- 4.2. The ADS shall interact safely with the authorized user in the vehicle¹

[Should this section be moved to follow after the current sections 4.3. and 4.4. given the intention to address ADS responses to safety-critical situations and failure modes at least in part via the ODD-based approach to scenario generation and assessment against safety models?]

Figure 2 — System-initiated transition from automated to manual driving

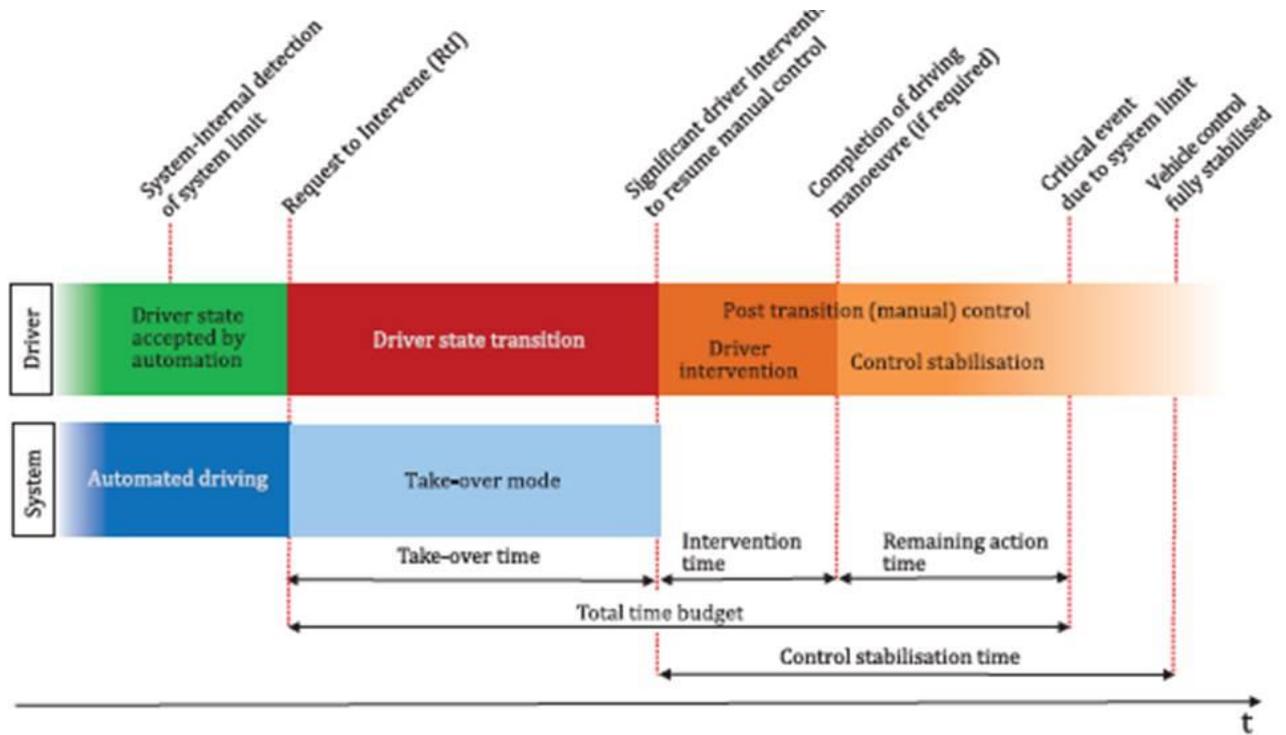
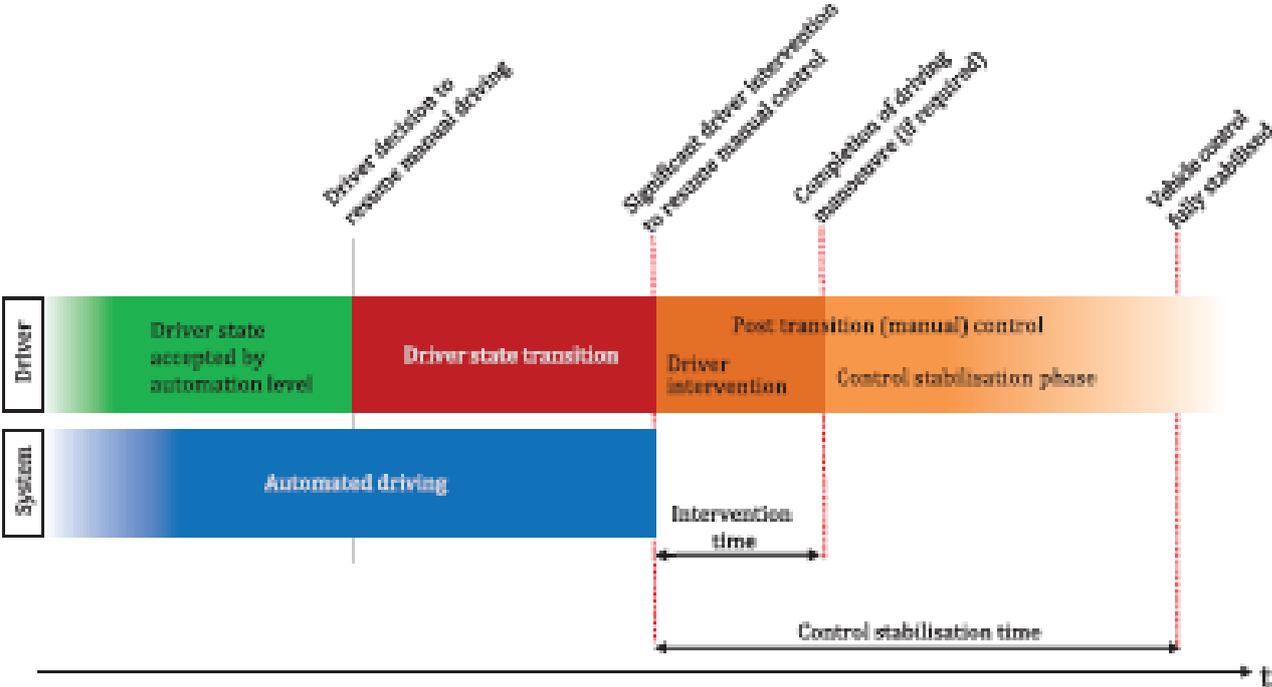
- 4.2.5.1 [The interaction shall follow a common sequence of actions and states in the Transition of control (change of user roles)
- a) Common sequence to be a pass/fail criterion [see Annex ?)]

- 4.2.6.2 [The deactivation shall follow a common sequence of actions and states in the transition of control (change of user roles)
- a) Common sequence to be a pass/fail criterion (see Annex ??)]
